## ADDENDUM #3

April 16, 2026

### UNCC Grigg Hall controls replacement SCO# 24-27749-01A

M5.1

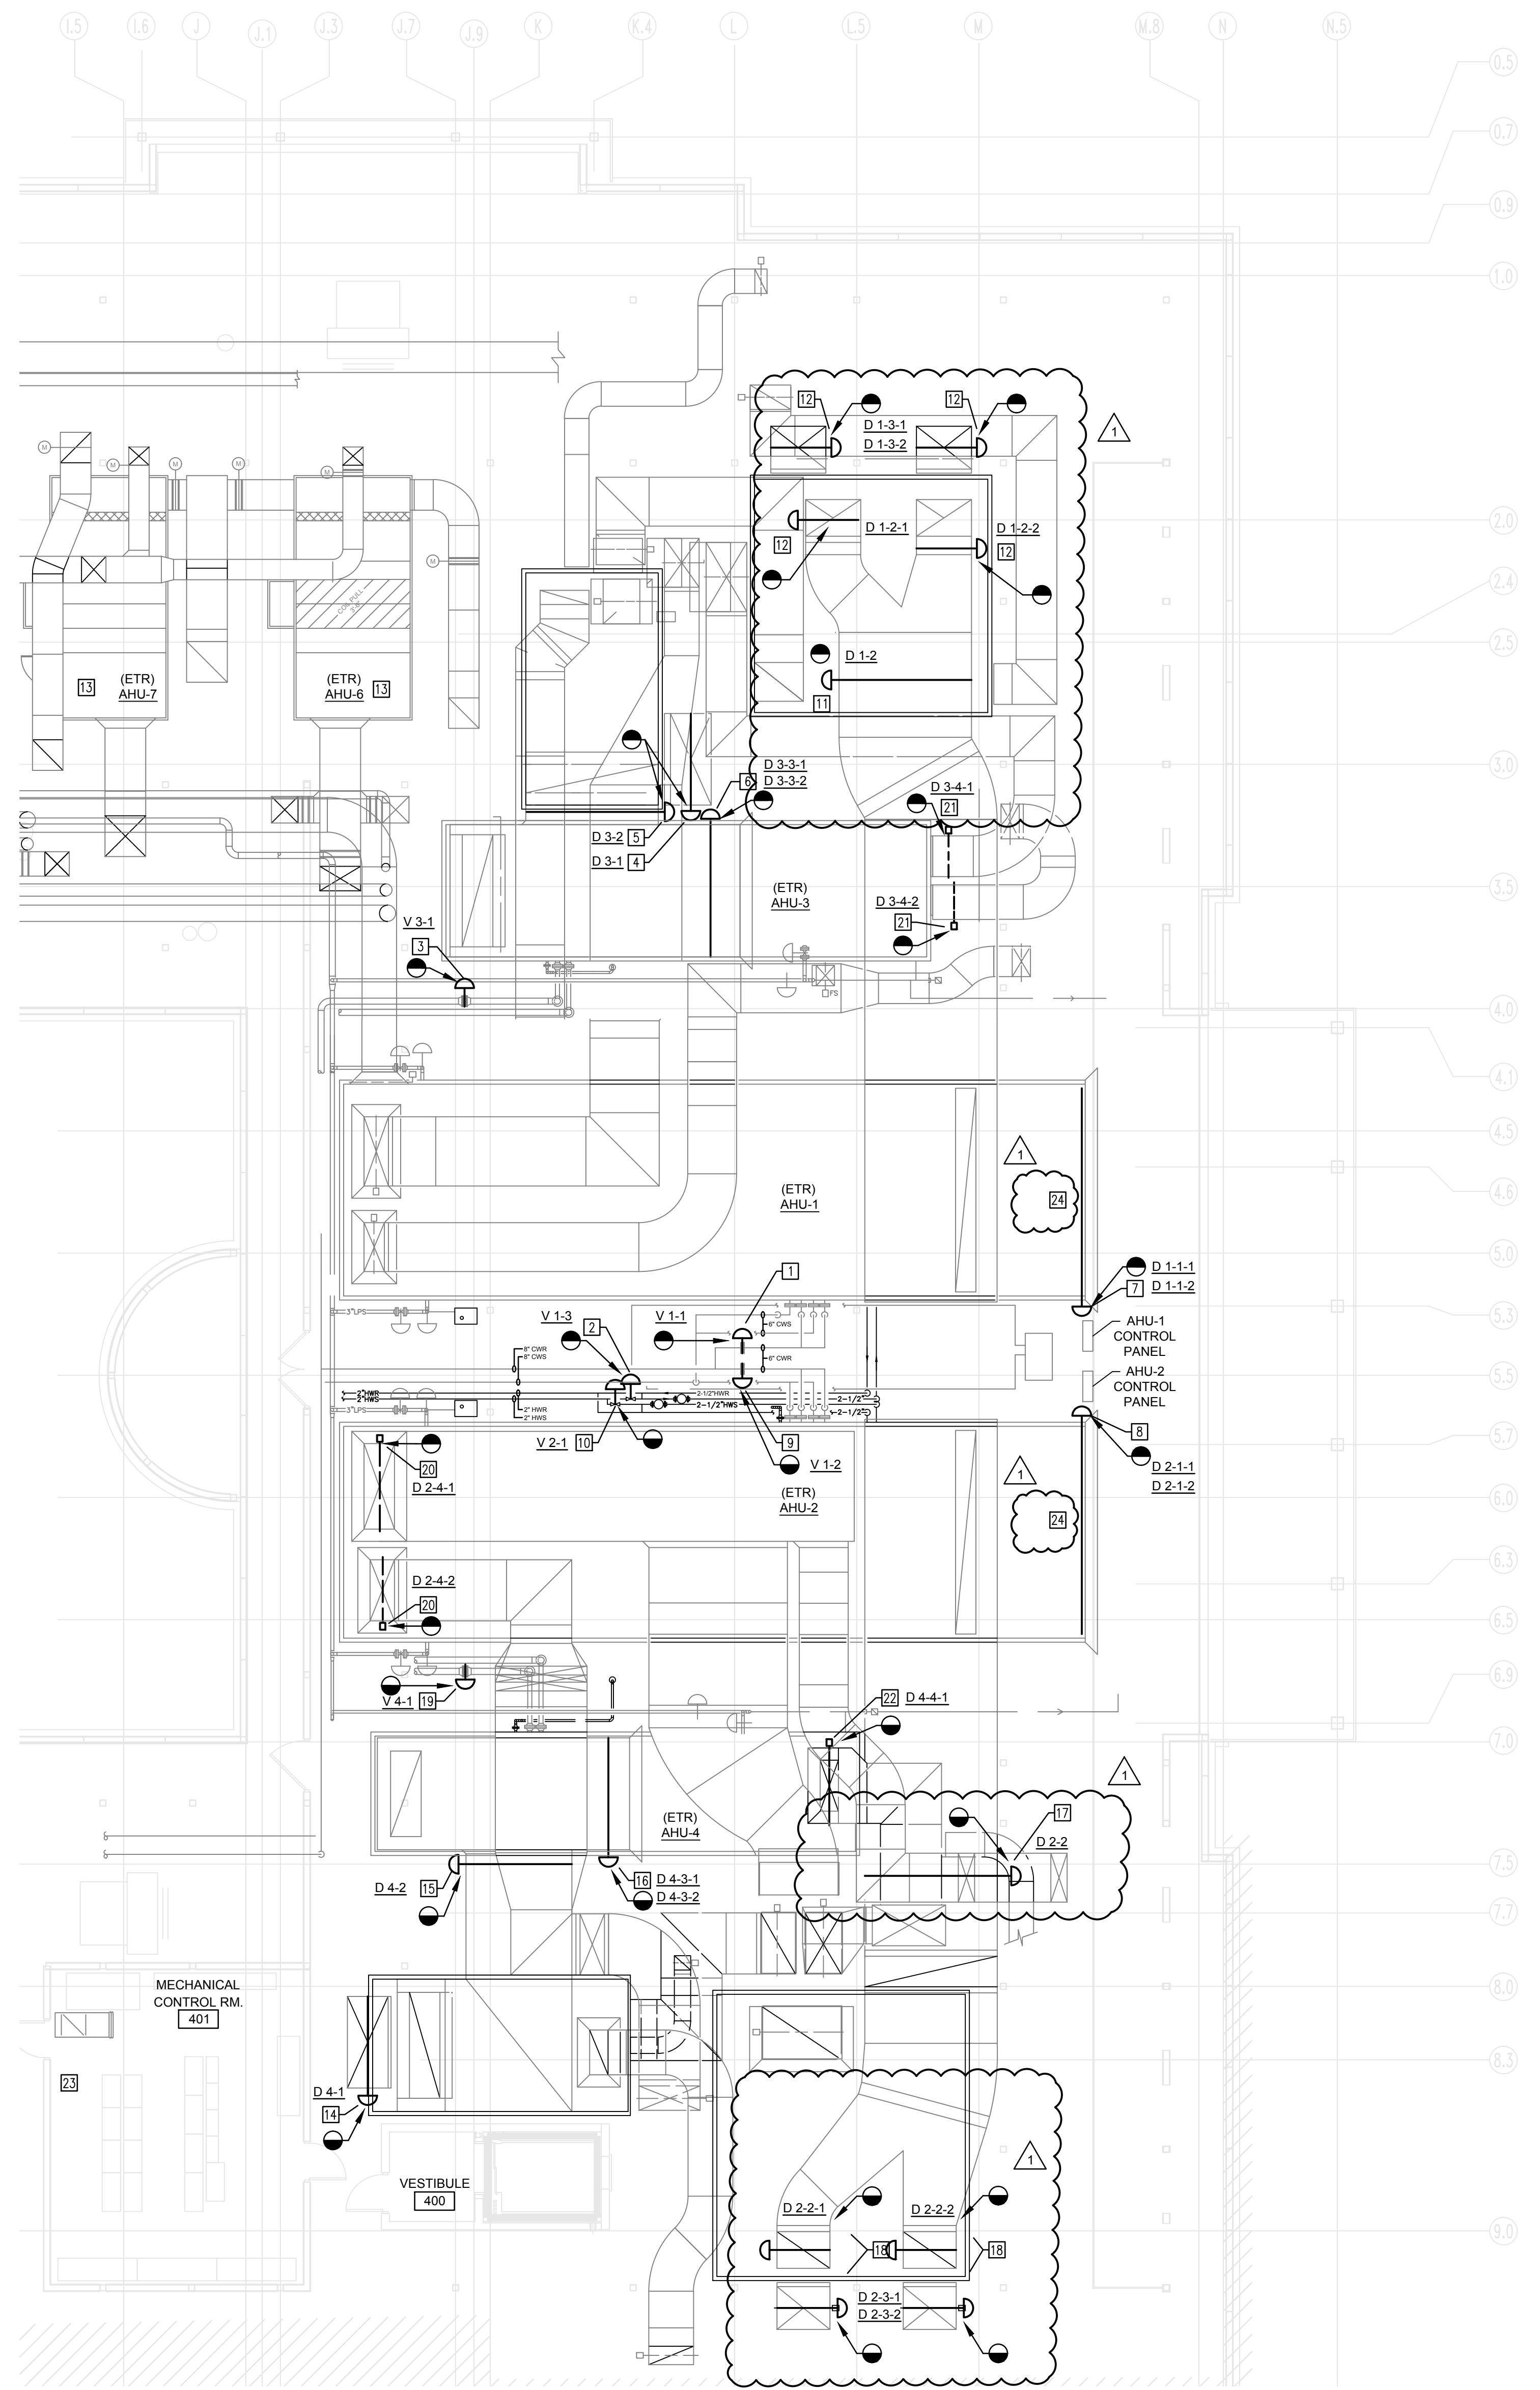
For replacement of damper actuators on AHU-1, it has been noted that the control diagram on sheet M5-1 does not exactly correlate with the AHU-1 plan on sheet M4-3. Please refer to the following clarification:

For replacement of damper actuators on AHU-2, it has been noted that the control diagram on sheet M5-1 does not exactly correlate with the AHU-2 plan on sheet M4-3. Please refer to the following clarification:

- EXISTING CONTROL SEQUENCES INDICATE THAT CONTROL DAMPERS EXIST AT THE INLETS TO RETURN FANS RF-1 AND RF-2. IF THERE ARE NO INLET CONTROL DAMPERS FOR RETURN AIR FANS, NOTIFY THE UNCC PM AND ENGINEER OF RECORD.

- A SINGLE COMMAND SIGNAL IS PROVIDED FOR RELIEF AIR DAMPERS AT RETURN FAN RF-1 AND RF-2, BUT THERE ARE TWO PHYSICAL DAMPERS WITH ACTUATORS. EACH RETURN AIR FAN CASING CONTAINS TWO PHYSICAL FANS, EACH WITH A SINGLE RELIEF DAMPER. DAMPERS ARE SHOWN ON ROOF PLAN M4-3.

Drawing No. **M4.3**

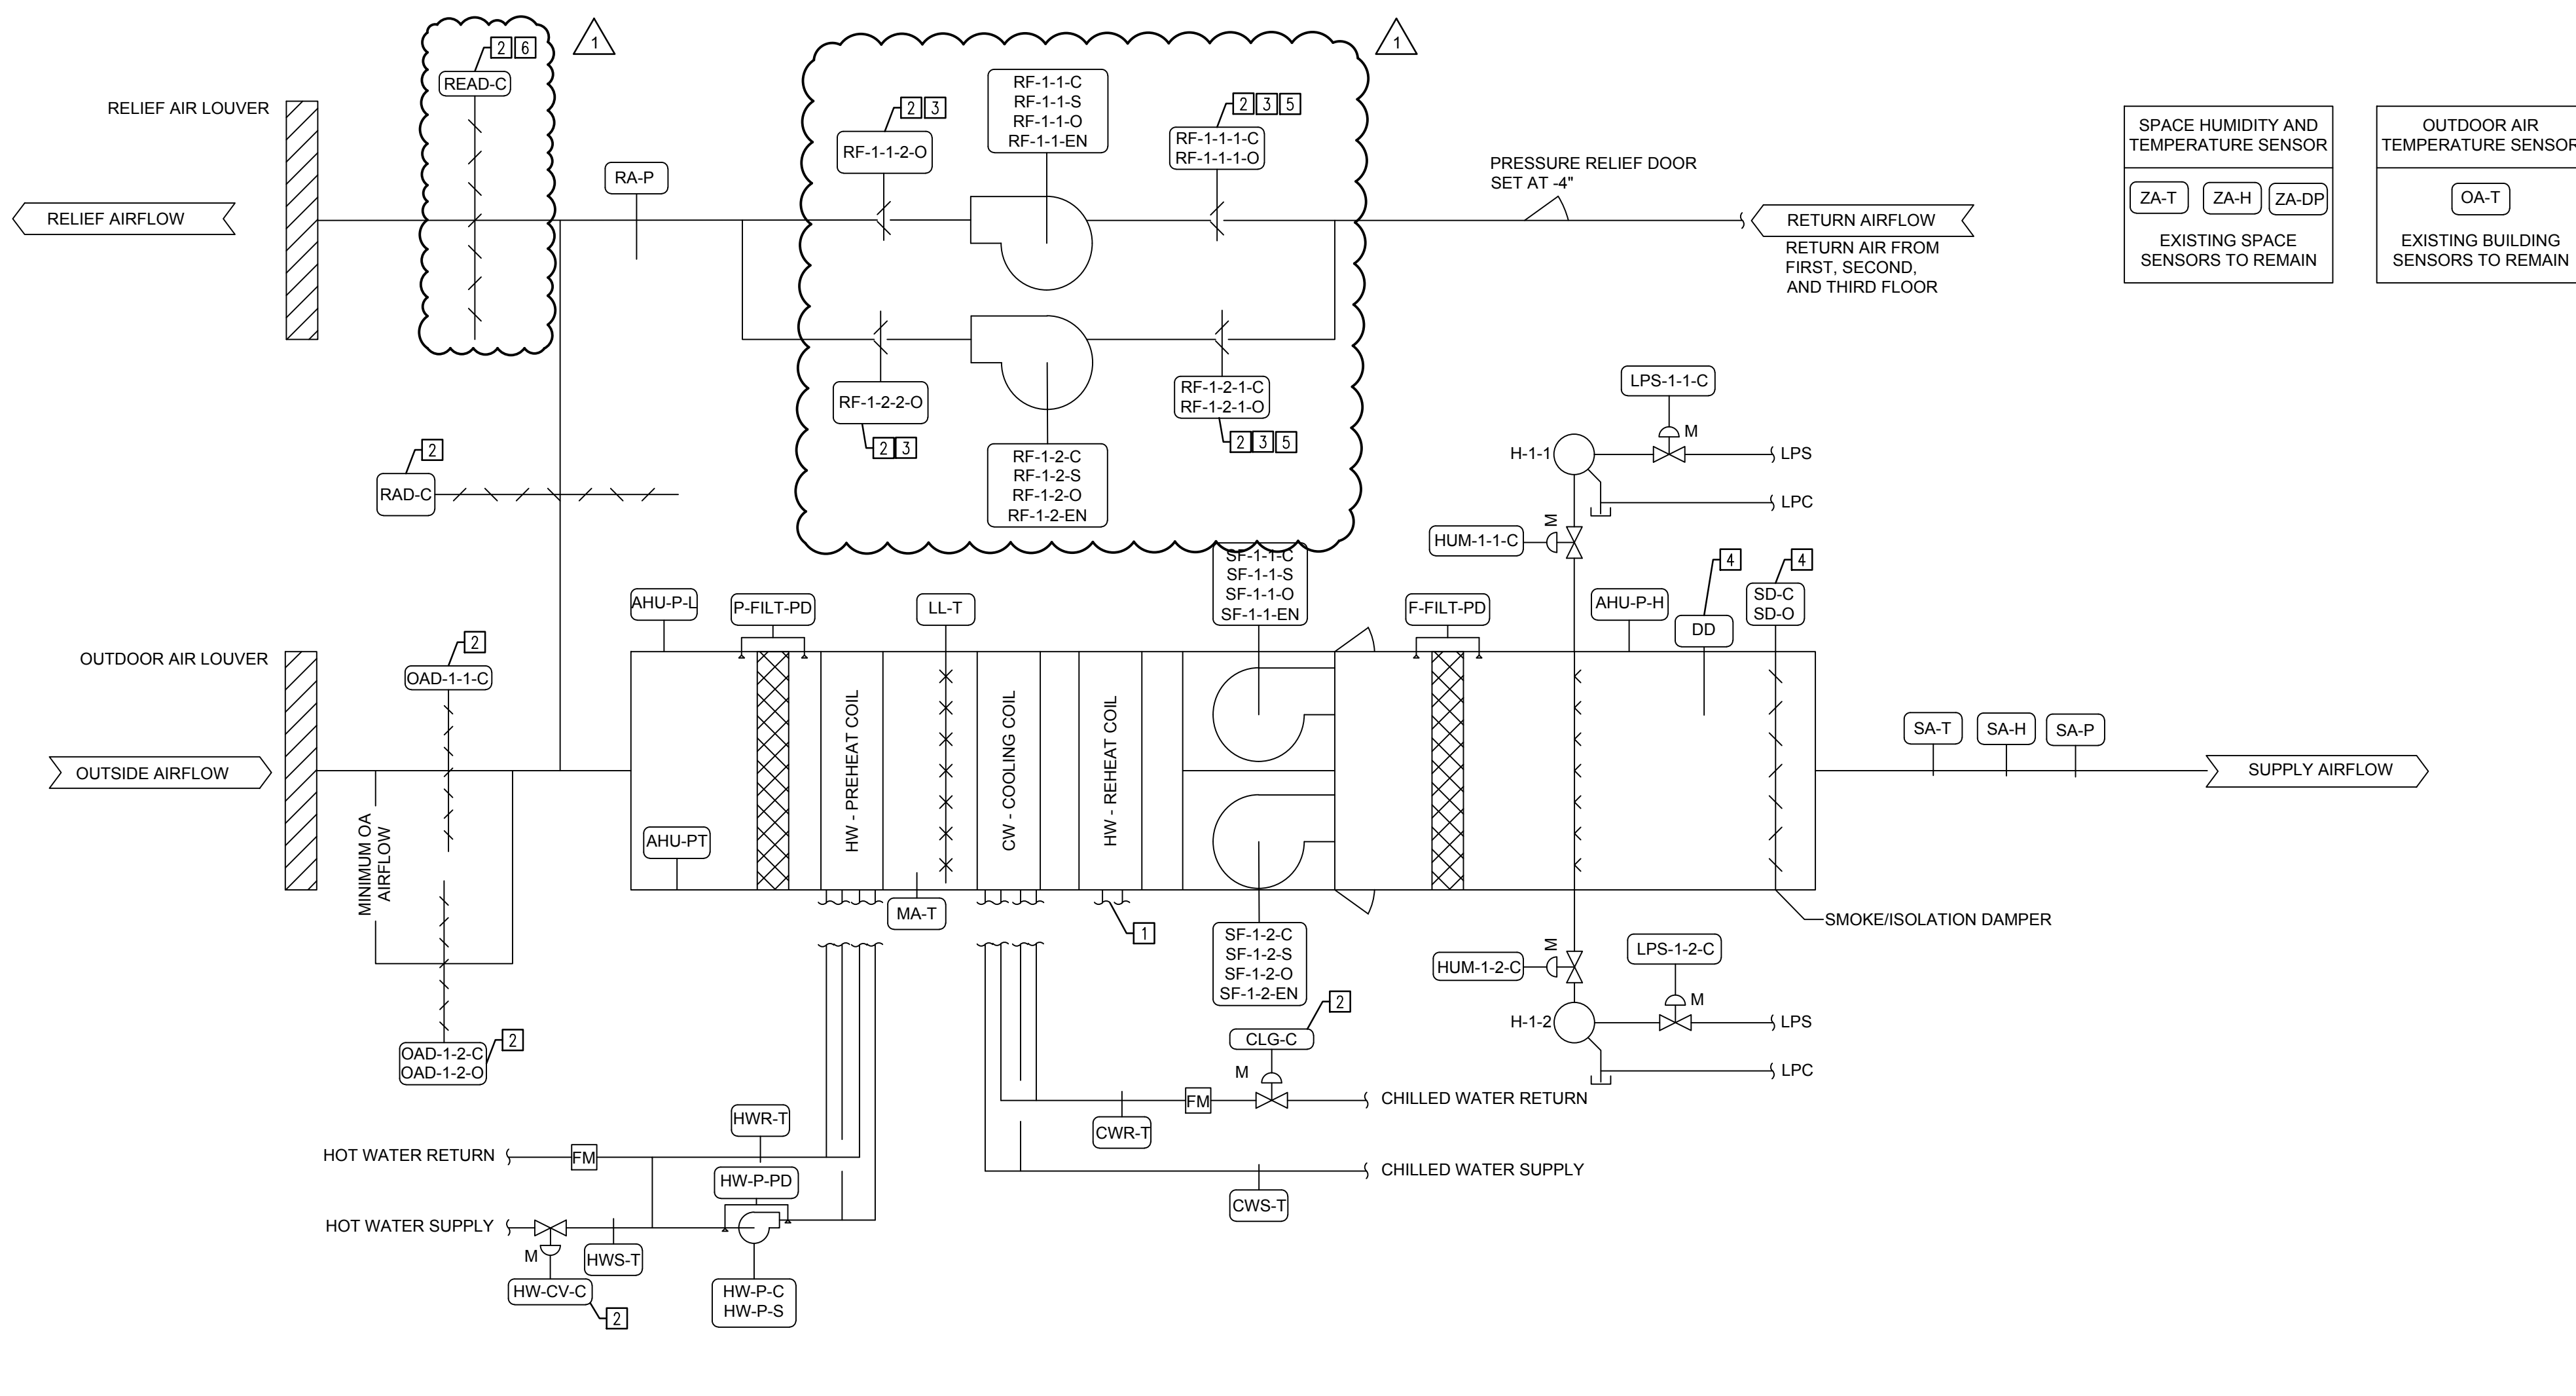
- Dampers D 1-1-1, and D 1-1-2 on sheet M4-3 correspond to OAD-1-1, and OAD-1-2 on sheet M5.1. Notes on drawings M4-3 have been updated to reflect that there are currently four pneumatic actuators serving the two outdoor air dampers.
- Dampers D 1-3-1, and D 1-3-2 on sheet M4-2 correspond to relief air damper 'READ' shown on sheet M5.1. This is in fact two dampers rather than a single damper/actuator.
- Damper D 1-2 on sheet M4-3 corresponds to return air damper 'RAD' on sheet M5-1. Drawing M4-3 has been updated to reflect this actuators location above RF-1 unit casing.
- Include in your bid replacement of RF-1-1, and RF-1-2 as shown on sheet M5.1, these correspond to additional dampers not originally show that have been added to sheet M4-3 in this addendum. These dampers are labeled as D 1-2-1, and D 1-2-2, and the actuators are located inside the unit casing of RF-1.

- Dampers D 2-1-1, and D 2-1-2 on sheet M4-3 correspond to OAD-1-1, and OAD-1-2 on sheet M5.1. Notes on drawings M4-3 have been updated to reflect that there are currently four pneumatic actuators serving the two outdoor air dampers.
- Dampers D 1-3-1, and D 1-3-2 on sheet M4-2 correspond to relief air damper 'READ' shown on sheet M5.1. This is in fact two dampers rather than a single damper/actuator.
- Damper D 2-2 on sheet M4-3 corresponds to return air damper 'RAD' on sheet M5-1. The location of this actuator has been updated on sheet M4-3.

- Include in your bid replacement of RF-1-1, and RF-1-2 as shown on sheet M5.1, these correspond to additional dampers not originally show that have been added to sheet M4-3 in this addendum. These dampers are labeled as D 2-2-1, and D 2-2-2, and the actuators are located inside the unit casing of RF-2.

- DEMOLISH EXISTING PNEUMATIC ACTUATOR ON OUTDOOR AIR DAMPER D 1-1-1 AND D 1-1-2 SERVING AHU-1. THE DAMPER HAS TWO EXISTING PNEUMATIC ACTUATORS. PROVIDE NEW DDC DAMPER ACTUATOR PER GENERAL NOTES ON THIS SHEET THAT MATCH THE OPERATION OF THE EXISTING CONTROLLERS.

- DEMOLISH EXISTING PNEUMATIC ACTUATOR ON OUTDOOR AIR DAMPER D 2-1-1 AND D 2-1-2 SERVING AHU-2. THE DAMPER HAS TWO EXISTING PNEUMATIC ACTUATORS. PROVIDE NEW DDC DAMPER ACTUATOR PER GENERAL NOTES ON THIS SHEET THAT MATCH THE OPERATION OF THE EXISTING CONTROLLERS.

- DEMOLISH EXISTING PNEUMATIC ACTUATOR ON RETURN AIR DAMPER D 1-2 SERVING AHU-1. PROVIDE NEW DDC DAMPER ACTUATOR PER GENERAL NOTES ON THIS SHEET.
- DEMOLISH EXISTING PNEUMATIC ACTUATOR ON RELIEF AIR DAMPER D 1-3-1 AND D 1-3-2 AND RETURN AIR DAMPERS D 1-2-1 AND D 1-2-2 SERVING AHU-1. PROVIDE NEW DDC DAMPER ACTUATORS PER GENERAL NOTES ON THIS SHEET. RELIEF DAMPERS ARE LOCATED IN WEATHER HOODS. RETURN DAMPERS ARE INSIDE THE FAN CASING.

- DEMOLISH EXISTING PNEUMATIC ACTUATOR ON RETURN AIR DAMPER D 2-2 SERVING AHU-2. PROVIDE NEW DDC DAMPER ACTUATOR PER GENERAL NOTES ON THIS SHEET.
- DEMOLISH EXISTING PNEUMATIC ACTUATOR ON RELIEF AIR DAMPER D 2-3-1 AND D 2-3-2 AND RETURN AIR DAMPERS D 2-2-1 AND D 2-2-2 SERVING AHU-2. RELIEF DAMPERS ARE INSIDE WEATHER HOODS. RETURN DAMPERS ARE INSIDE FAN CASING. PROVIDE NEW DDC DAMPER ACTUATORS PER GENERAL NOTES ON THIS SHEET.

- THERE ARE A TOTAL OF FOUR EXISTING PNEUMATIC ACTUATORS SERVING TWO SECTIONS OF OUTDOOR AIR DAMPER. ONE CONTROLS FOR MINIMUM OUTDOOR AIR CONDITION, THE OTHER FOR MAXIMUM OUTDOOR AIRFLOW. USE OF A SINGLE DDC ACTUATOR PER DAMPER SECTION, FOR A TOTAL OF TWO DDC ACTUATORS, IS ACCEPTABLE.
